Addendum: **2**

Date: **5/13/2025**

Project: **FWCS HPB Natatorium HVAC Improvements**

Comm #: **24634**

TITLE:

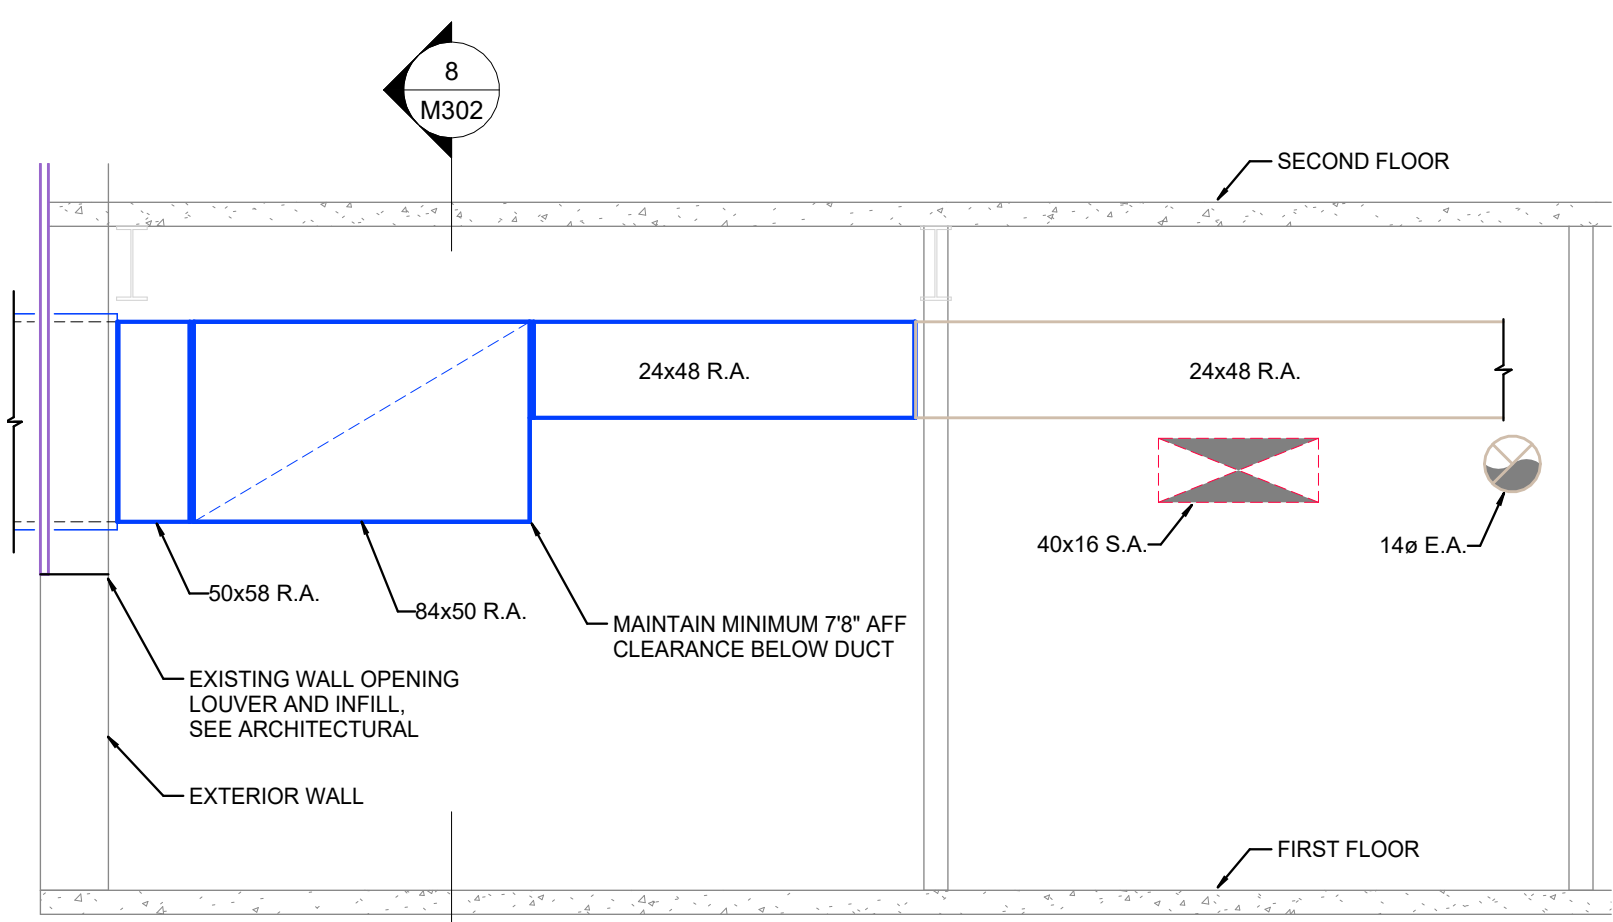
- A.** Revise glazing details. Refer to attached drawing revision dated 5/13/2025.

Item #5: Drawing Sheet M301, "Enlarged Mechanical Plan and Sections."

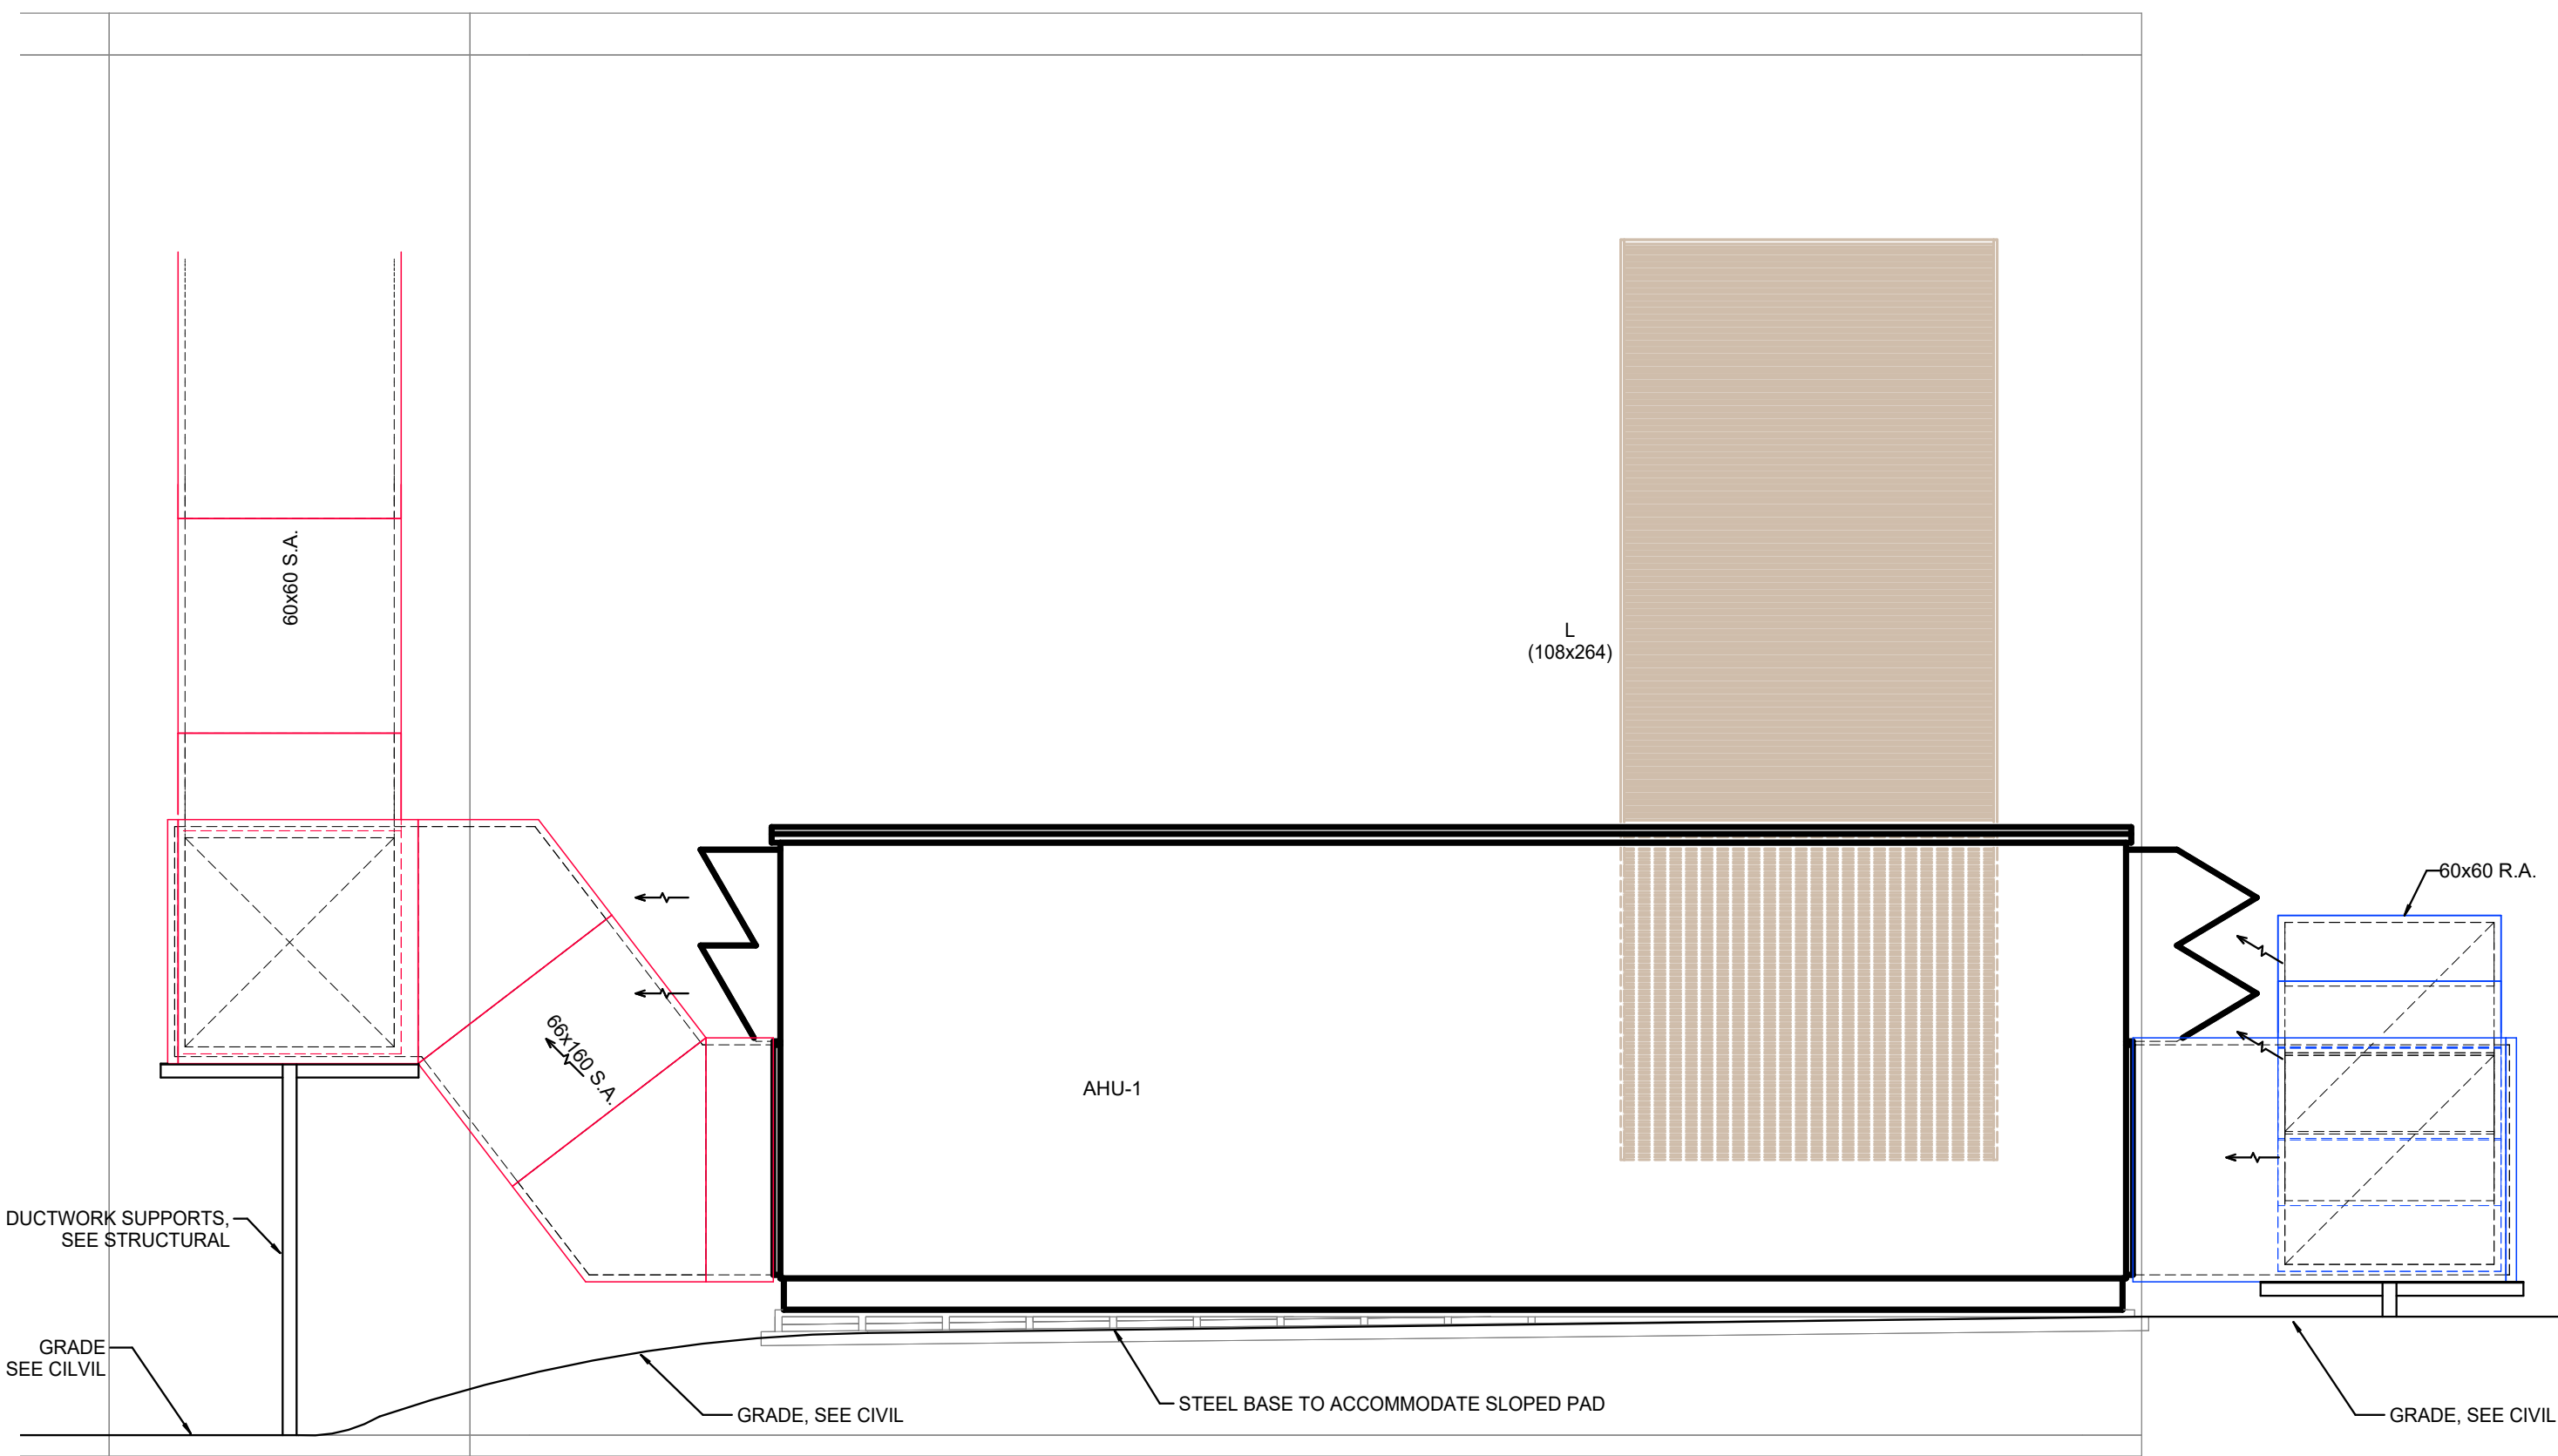
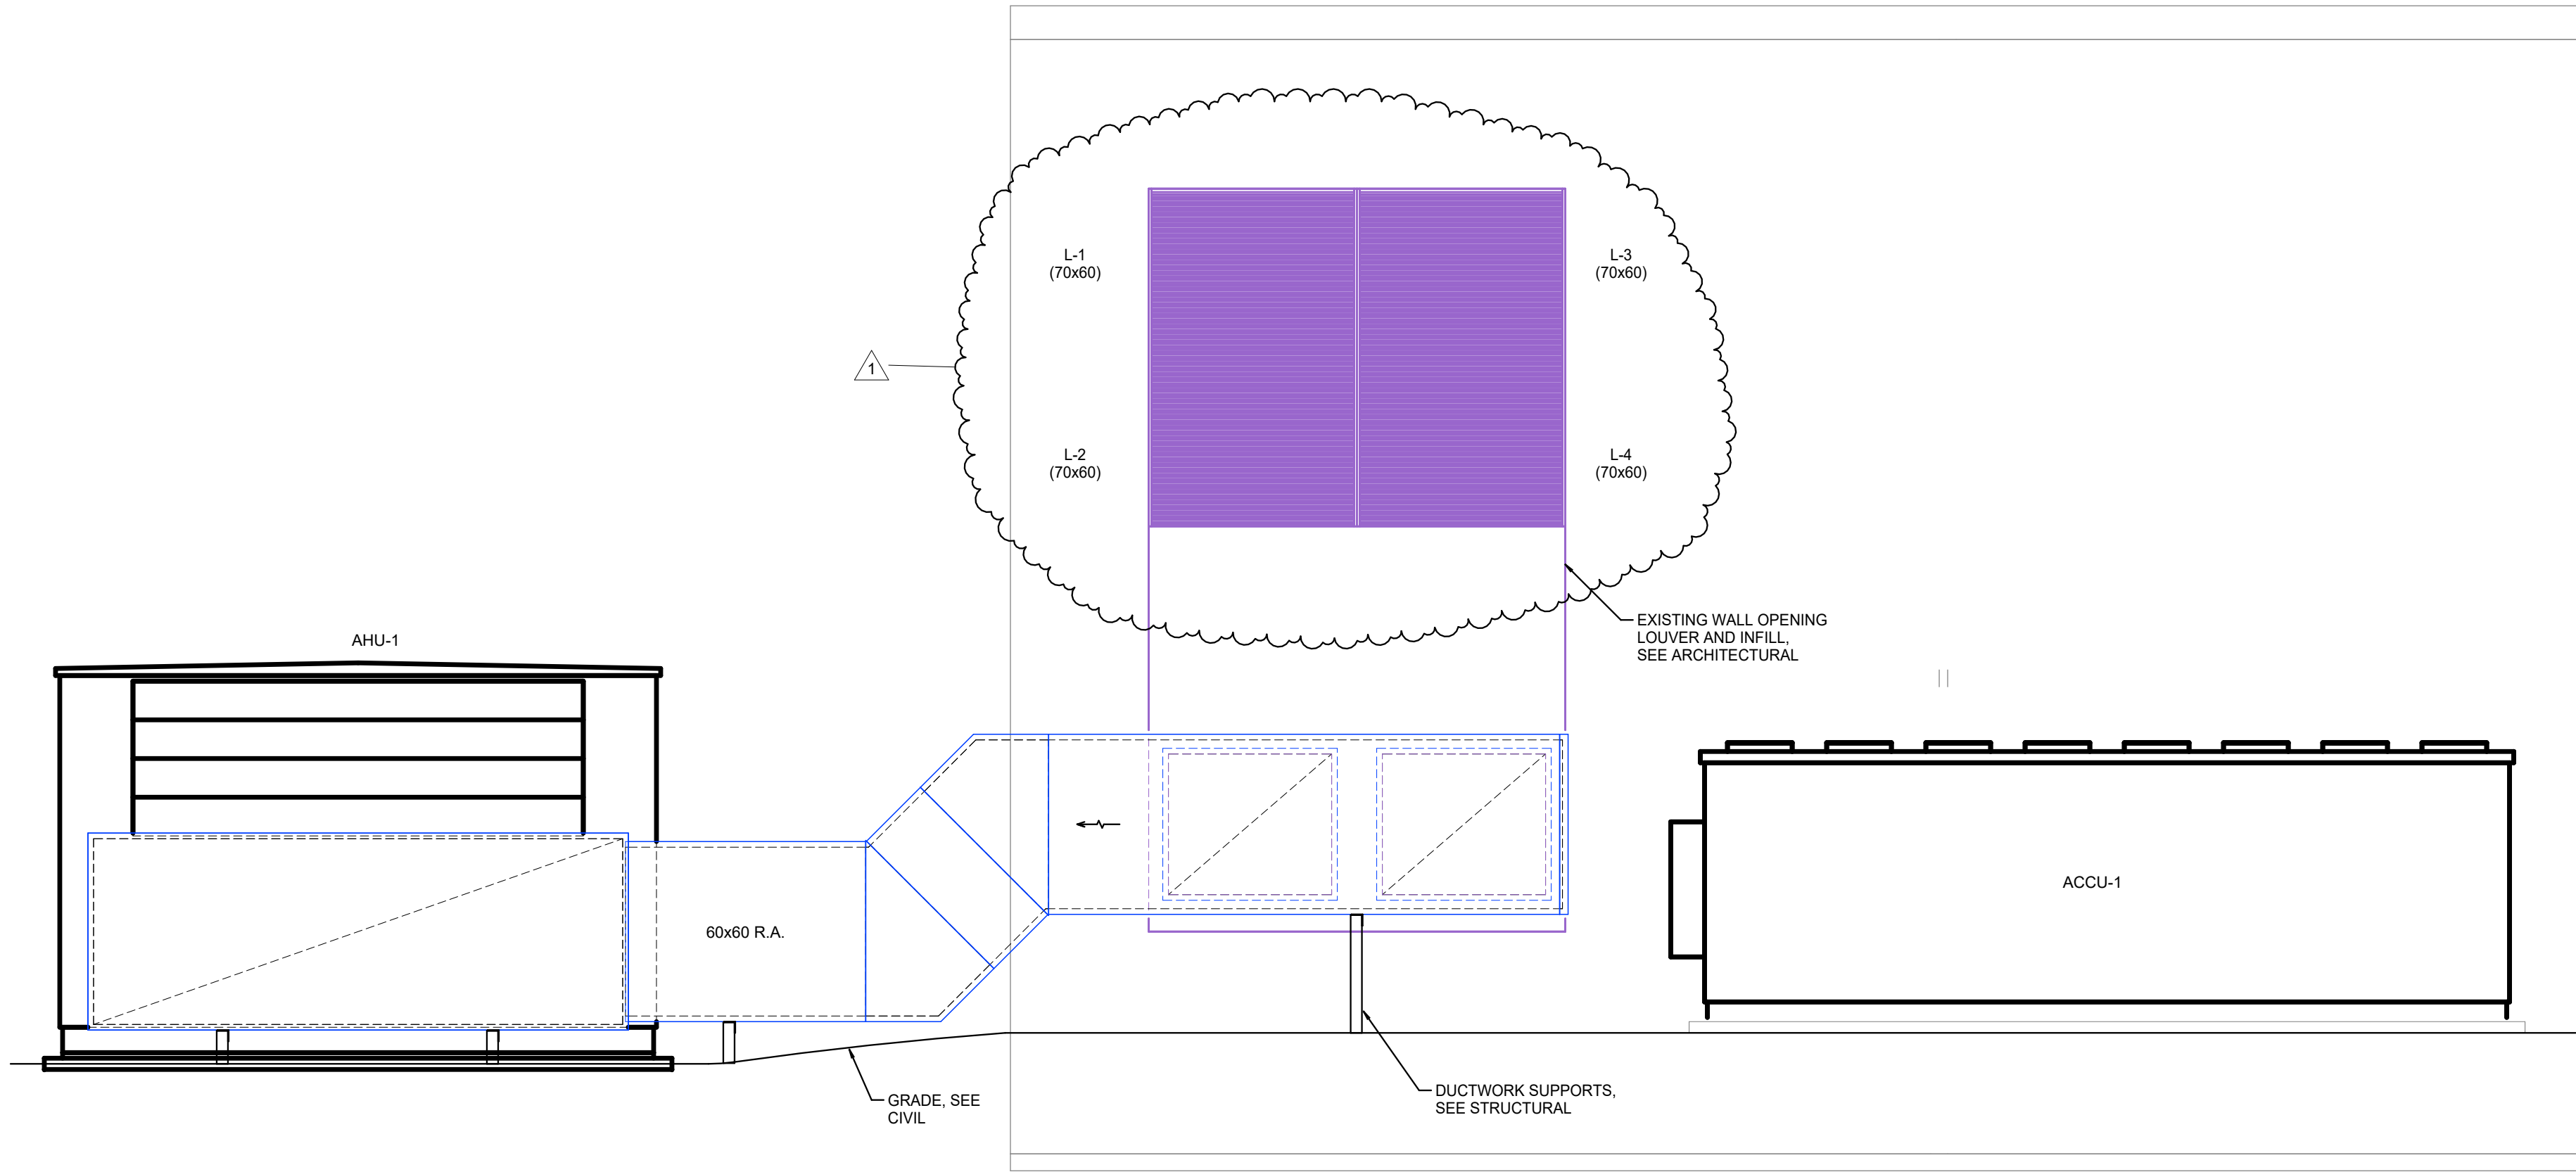
- A.** Revise louvers L-1 and L-2 to be louvers L-1, L-2, L-3, and L-4. Refer to attached drawing revision dated 5/13/2025.
